NCUTCD Proposal for Changes to the Manual on Uniform Traffic Control Devices

17B-TTC-01 v3

Clarification on the use of a Double Headed Arrow to Indicate an Interior Lane Closure, with proposed modifications to Section 6F-23, Table 6F-1, Figure 6F-4, Figure 6H-38, notes for TA-38, and a new Section 6F-XX.

Figure 6H-38. Interior Lane Closure on a Freeway (TA-38)

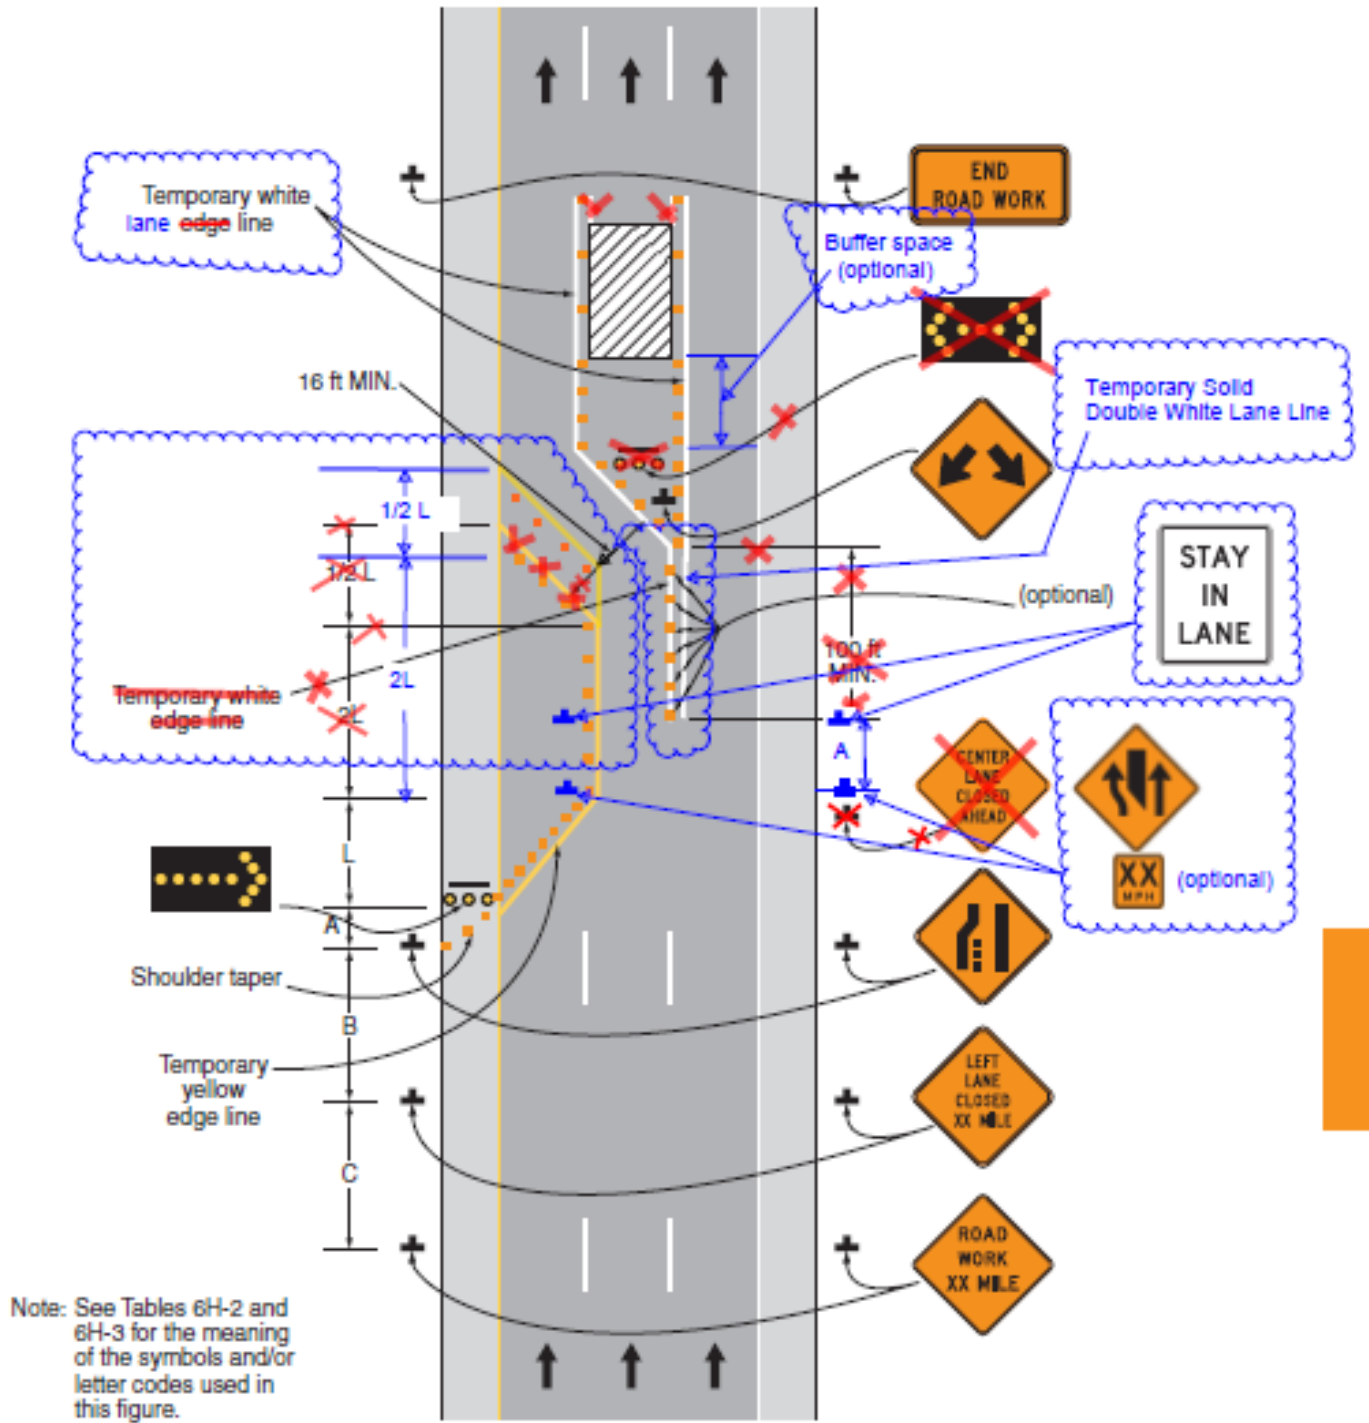
The Temporary Traffic Controls Technical Committee recommends a clarification to the use of the arrow board located at the point of diversion as shown in Figure 6H-38 of TA-38, Interior Lane Closure on a Freeway. This recommendation requires modifications to Figure 6H-38, Interior Lane Closure on a Freeway.

- 145 5. For a long-term closure, a barrier should be used to provide additional safety to the
- 146 operation in the closed interior lane. A buffer space should be used at the upstream end
- 147 of the closed interior lane.
- 148 6. The ~~first~~ arrow board displaying an arrow pointing to the right should be on the left-
- 149 hand shoulder at the beginning of the taper. ~~The arrow board displaying a double~~
- 150 ~~arrow should be centered in the closed interior lane and placed at the downstream~~
- 151 ~~end of the shifting taper.~~
- 152 7. ~~If the two arrow boards create confusion, the 2L distance between the end of the~~
- 153 ~~10. merging taper and beginning of the shift taper should be extended so that road~~
- 154 ~~users can focus on one arrow board at a time.~~
- 155 8. ~~The placement of signs should not obstruct or obscure arrow boards.~~

162 8a. The Interior Lane Shift Ahead (W9-4) symbol sign may be mirrored to indicate a right
163 lane shift.

Figure 6F-4. Warning Signs and Plaques in Temporary Traffic Control Zones
(Sheet 2 of 3)

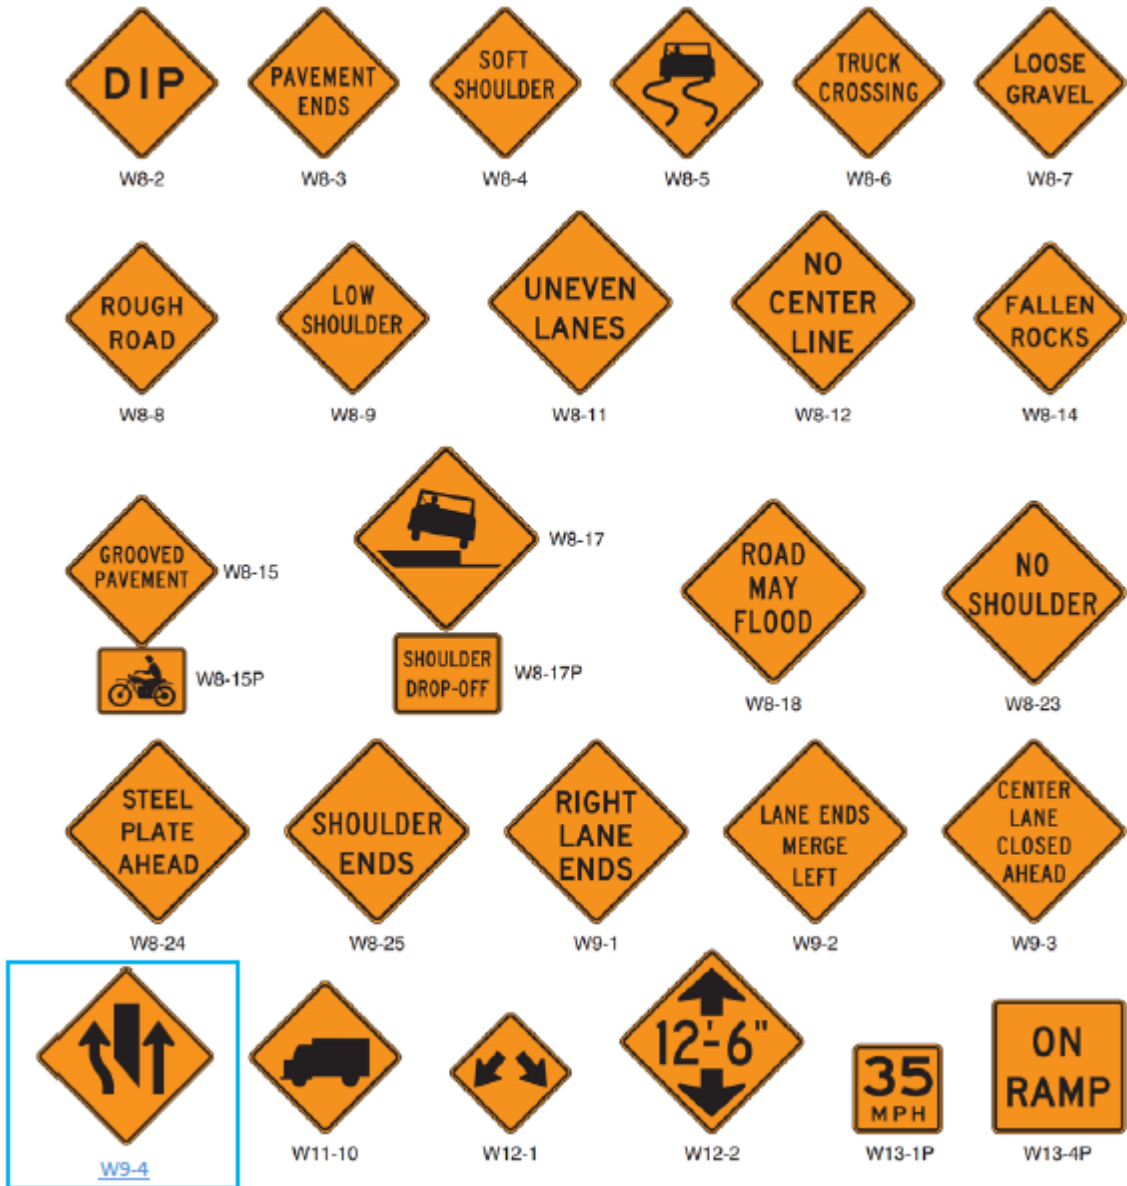
94
95 As a result, information on this new sign designation should be added to Table 6F-1 Temporary
96 Traffic Control Zone Signs and Plaque Sizes (Sheet 2 of 3), and to Figure 6F-4 Warning Signs
97 and Plaques in Temporary Traffic Control Zones (Sheet 2 of 3).
